SECTION 12A PLANNING APPLICATION NO. Y/YL-TYST/12

Further Information Submission

Section 12A Planning Application No. Y/YL-TYST/12

Response to Departmental Comments Table

Diagram 7 Fui Sha Wai South Road (VP2)

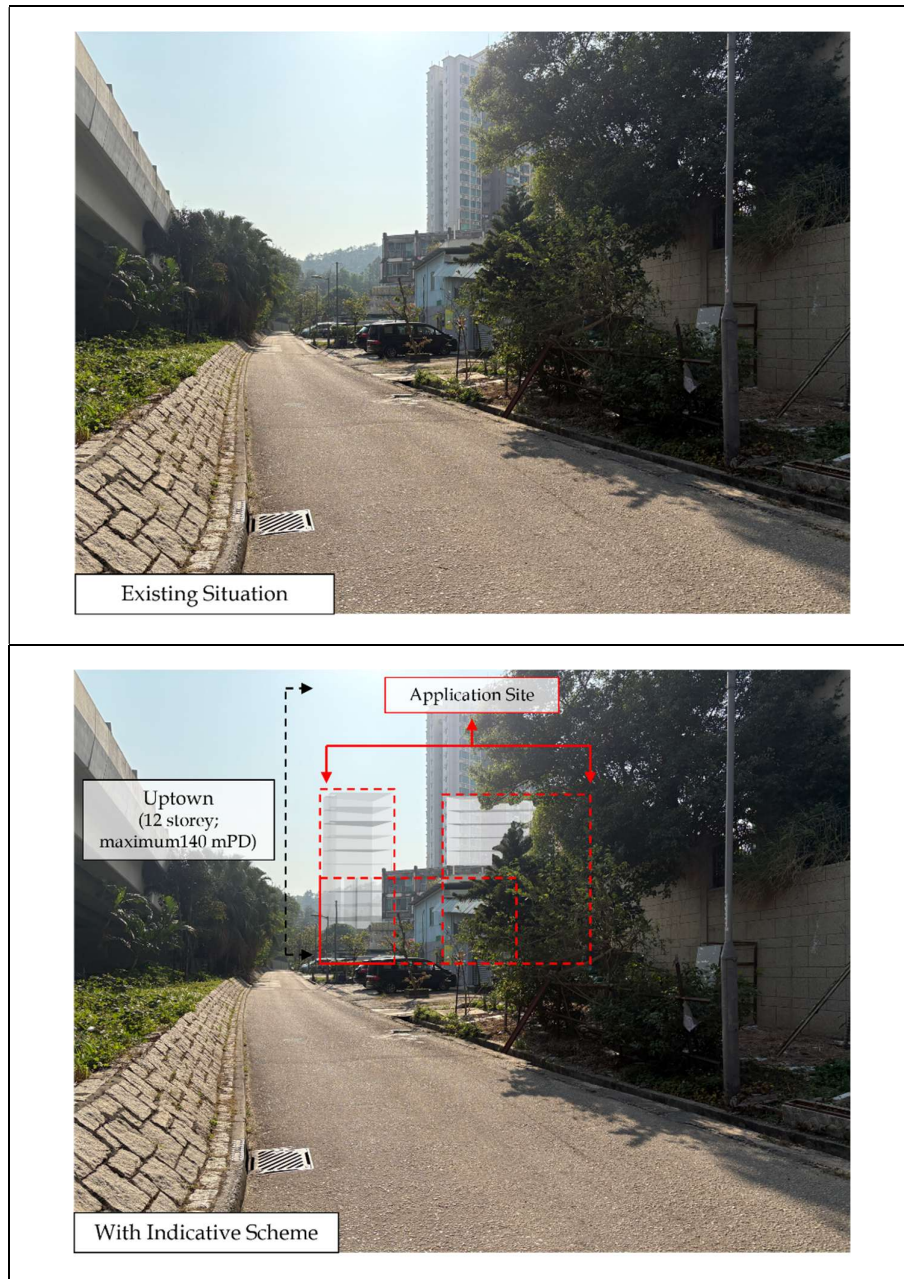
b.	VP2 – paras. 4.2.6 and 4.2.7 and diagram 7 – the proposed development should appear to be wider and taller (i.e. screening the entire mountain backdrop and half of the open sky) and in front of Uptown at the foreground in the photomontage. The assessment should also be revised accordingly;	Section 4.2.7 and Diagram 7 of VA have been revised accordingly.

- 4.2.7 The photomontage demonstrates that with and without the Proposed Development, the **public viewers** at this VP will experience **slight** visual change. Due to the transient nature of road and lane users, and the fact that the Application Site is largely obscured by existing infrastructure and surrounding residential developments, the visual impact of the Proposed Development is considered **moderate**.
- 4.2.8 The inclusion of peripheral planting in the Proposed Development will ensure a degree of visual permeability, maintaining compatibility with the surrounding built environment.
